Piper Aircraft, Inc.
2926 Piper Drive
Vero Beach, Florida, U.S.A. 32960

SERVICE NO. 1258

BULLETIN

FUEL VENT VALVE INSPECTION

Figure 1

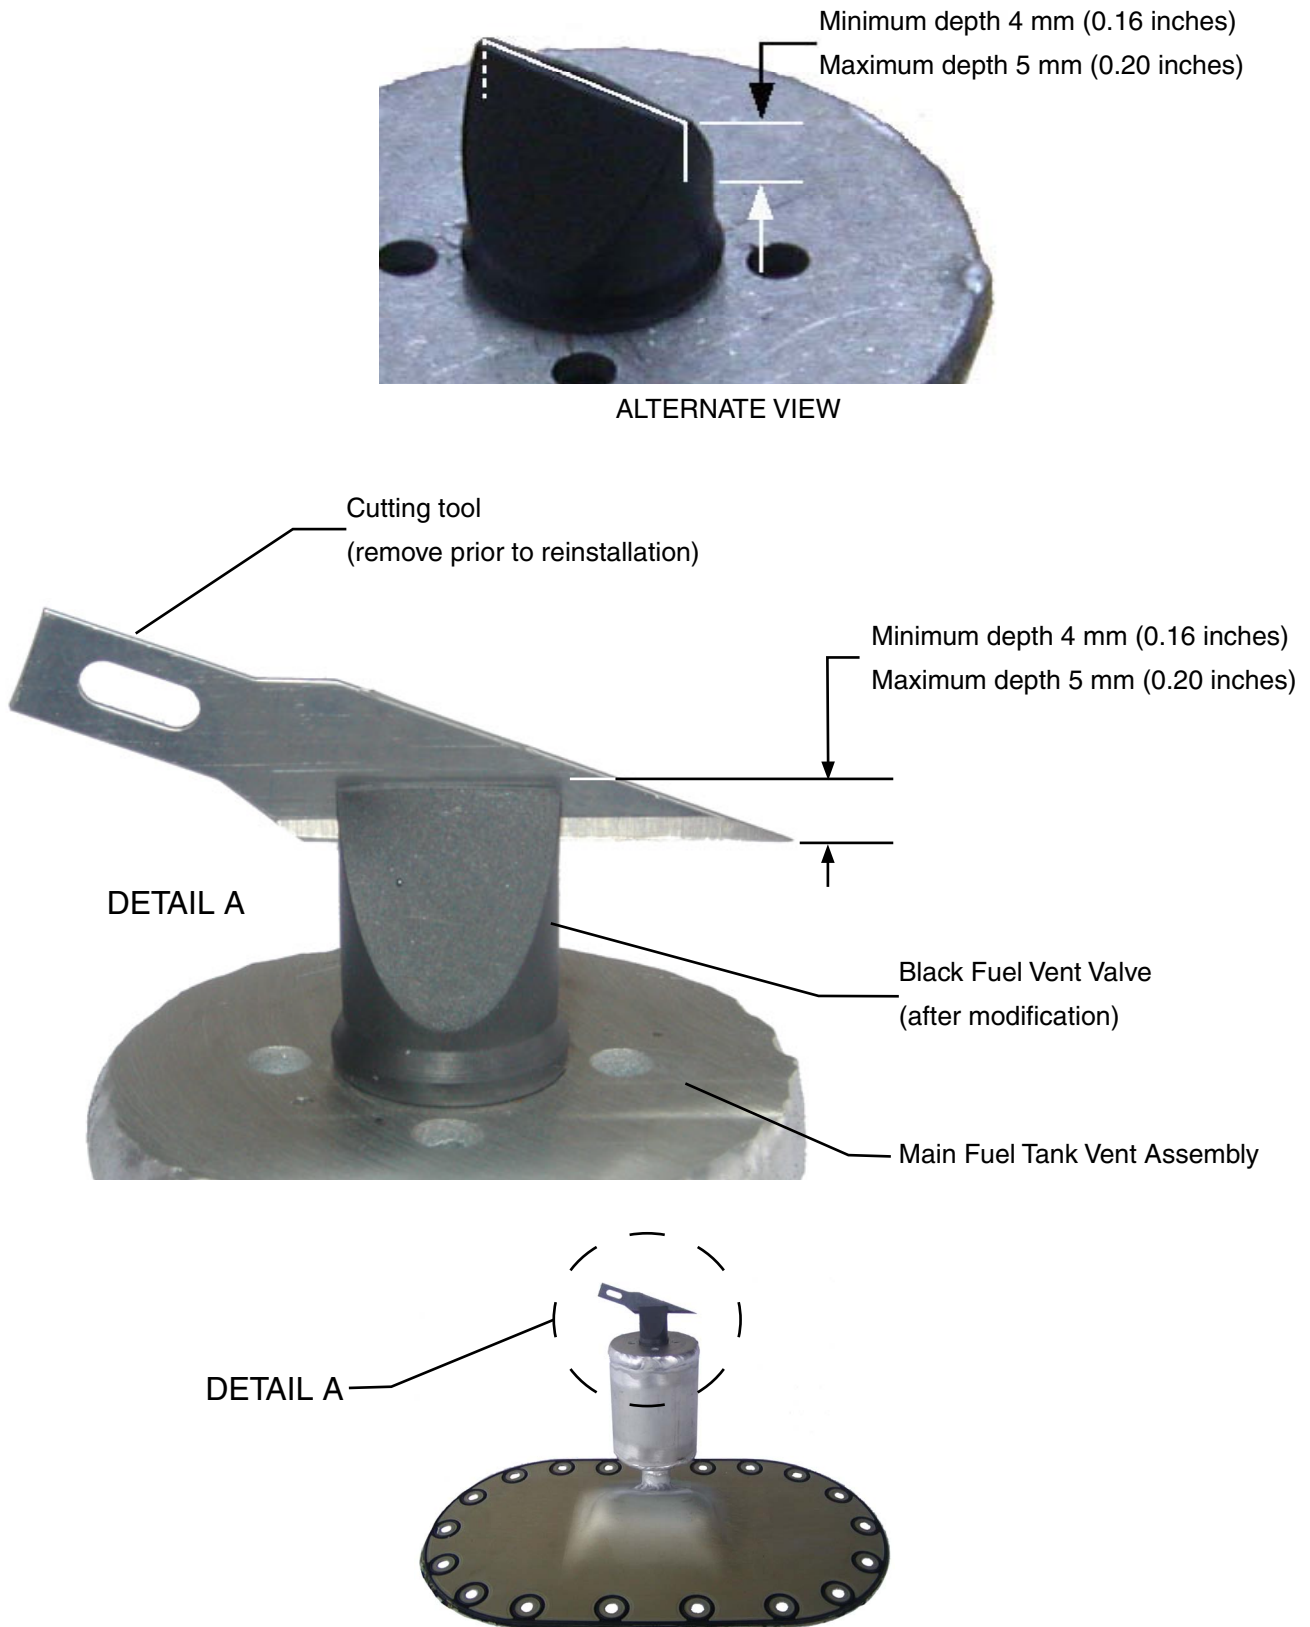
1. Remove the main fuel tank vent assembly, retaining all screws for later reinstallation.
2. Using a razor blade, scalpel or other suitable sharp tool, carefully slice the duck bill portion of the black fuel vent valve, as shown in Figure 1.

NOTE: When properly completed, the existing (prior) opening at the end of the duckbill will reside on the same plane of symmetry as the enlarged (newly cut) opening.

NOTE: Cutting tool shown for illustration purposes only, to clarify depth of cut. Remove cutting tool prior to reinstalling the main fuel tank vent assembly.

Figure 2
Fuel Vent Valve Features

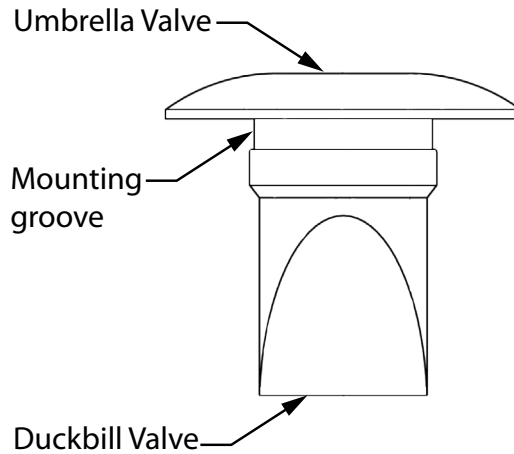
NOTE: Refer to Figure 2 of this service bulletin to identify the fuel vent valve features mentioned in the instructions that follow.

1. Order replacement orange fuel vent valve(s), Piper part number 106927-001, quantity 1 or 2, as required.
2. Remove the main fuel tank vent assembly, retaining all screws for later reinstallation.
3. Grip the exposed, duckbill portion of the black fuel vent valve with pliers. Using a pulling/twisting motion, carefully remove the fuel vent valve from the main fuel tank vent assembly, and discard fuel vent valve.

NOTE: The entire black fuel vent valve must be removed from the main fuel tank vent assembly prior to proceeding.
4. Using finger pressure, fold the umbrella valve portion of the replacement orange fuel vent valve towards the duckbill valve, and press the fuel vent valve into the circular opening of the main fuel tank vent assembly, continuing until the umbrella portion is completely through the opening, and no further.

5. Grip the duckbill of the fuel vent valve between the thumb and forefinger, and slowly pull the fuel vent valve out, stopping when the mounting groove seats against the opening of the main fuel tank vent assembly.
